Subject CIB - Utilities - AT&T West 3rd Relocation

AT&T West 3rd Street Demo (R1).pdf

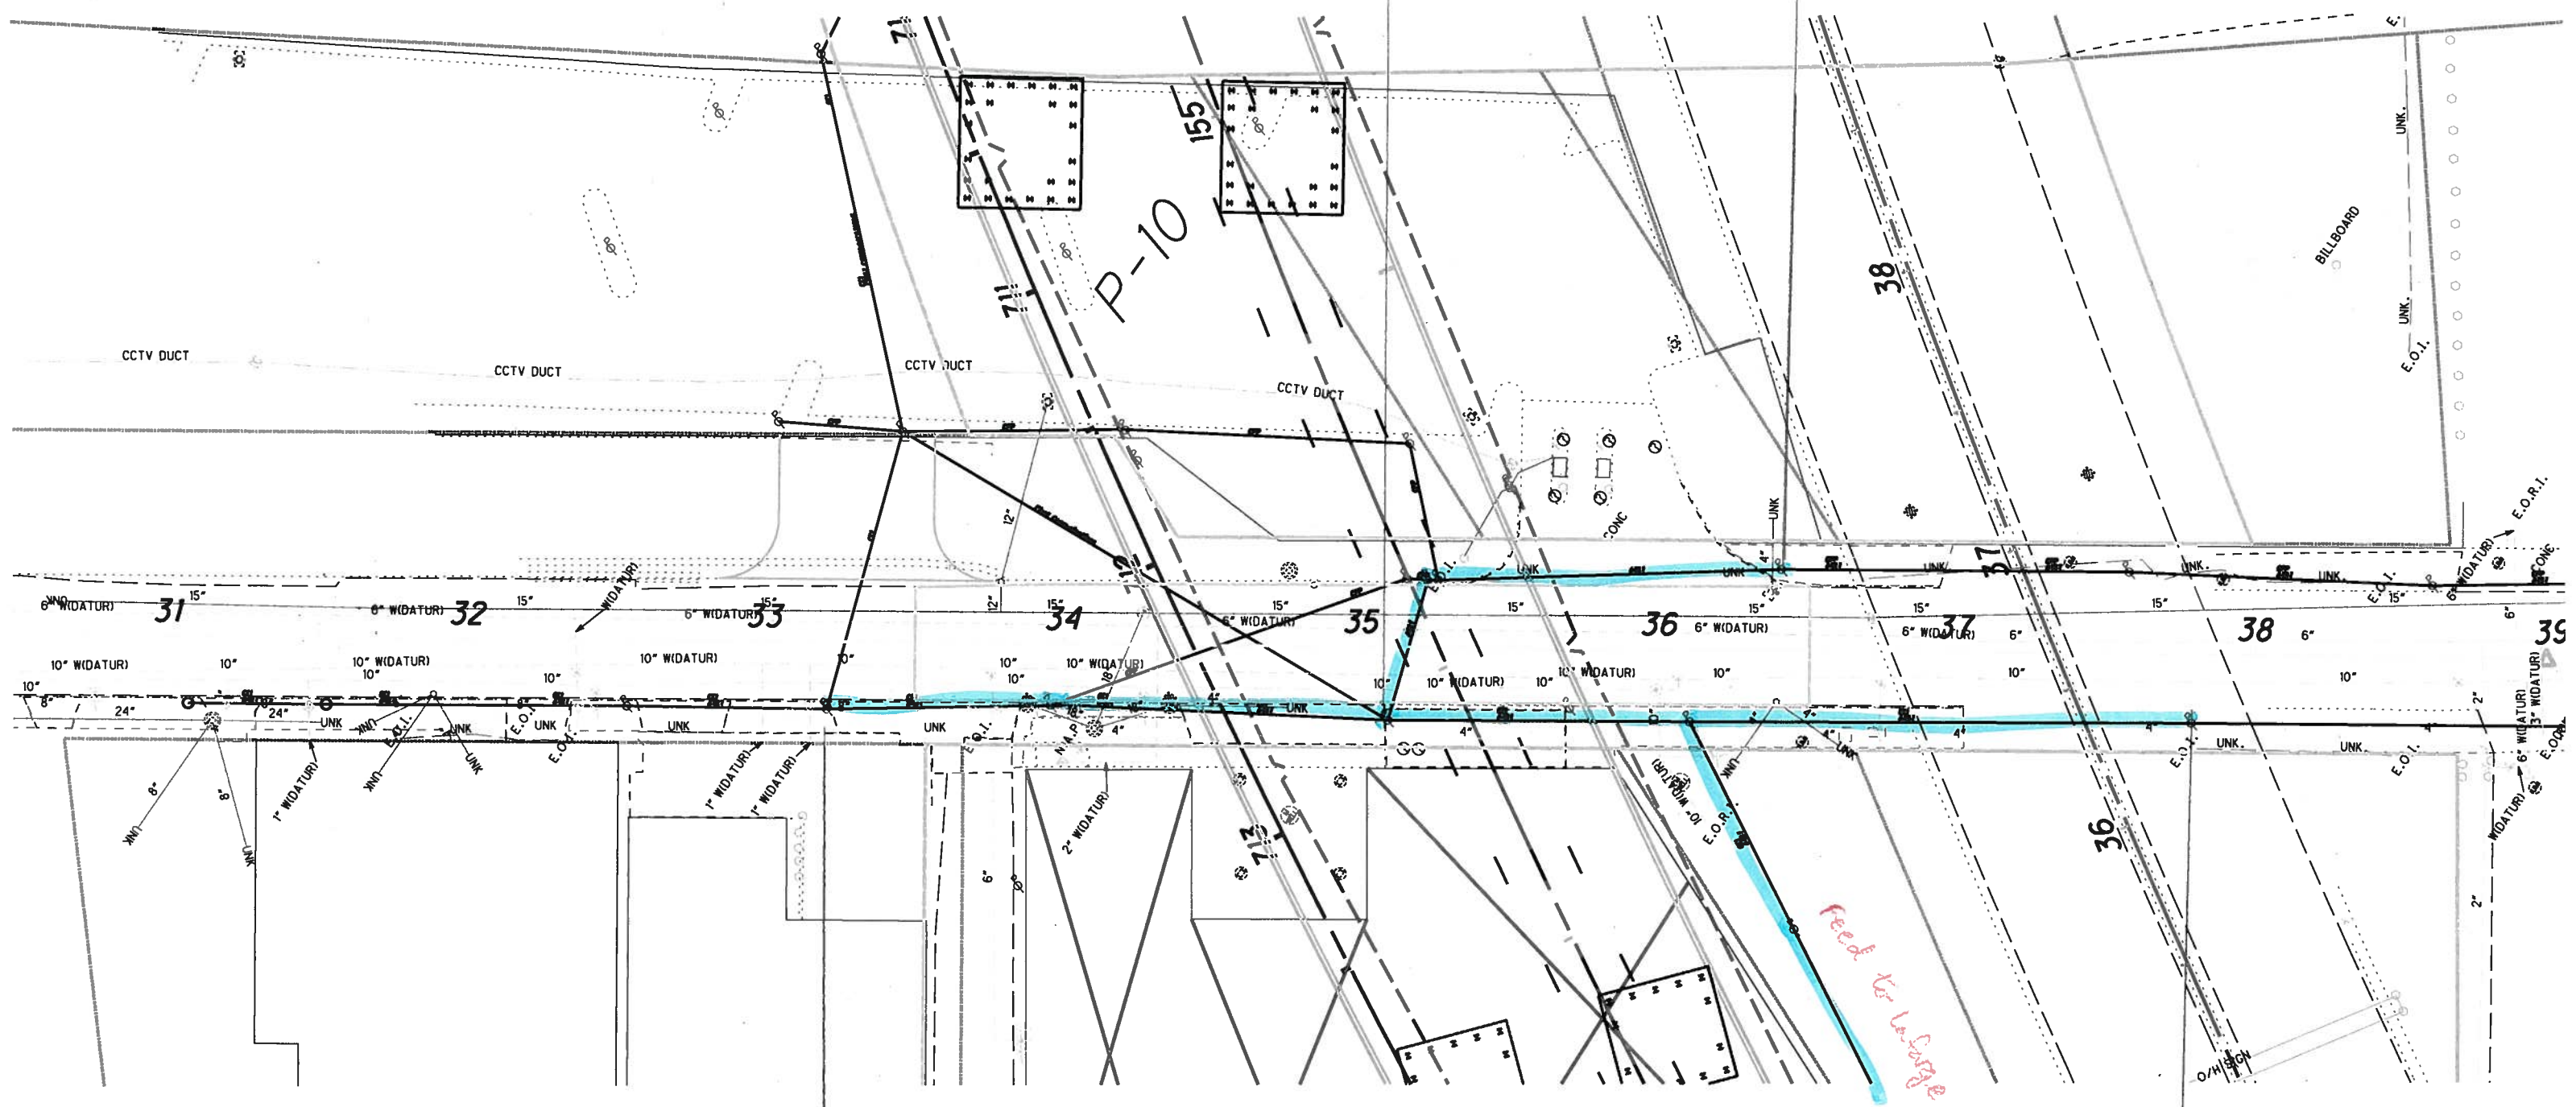
Attached are the limits that AT&T will need to relocate at West 3rd. I believe the Fiber Optic crossing West 3rd at Sta. 35+00 is theirs. We'll confirm when we meet with Eric.

ATTN NEEDS TO REMOVE
OVERHEADS IN THIS AREA
EAST OF WEST 3RD ST. 2200 LF
COP POLES TO BE DEMO'D

ATTN NEEDS TO REMOVE OVERHEAD
IN THIS AREA WEST OF WEST 3RD ST: 2 460 LF
(PLUS OVERHEAD FEED TO LAFARGE)
ATTN ON CFI POLES ON WEST SIDE OF W. 3RD ST. TO BE DEMO'D
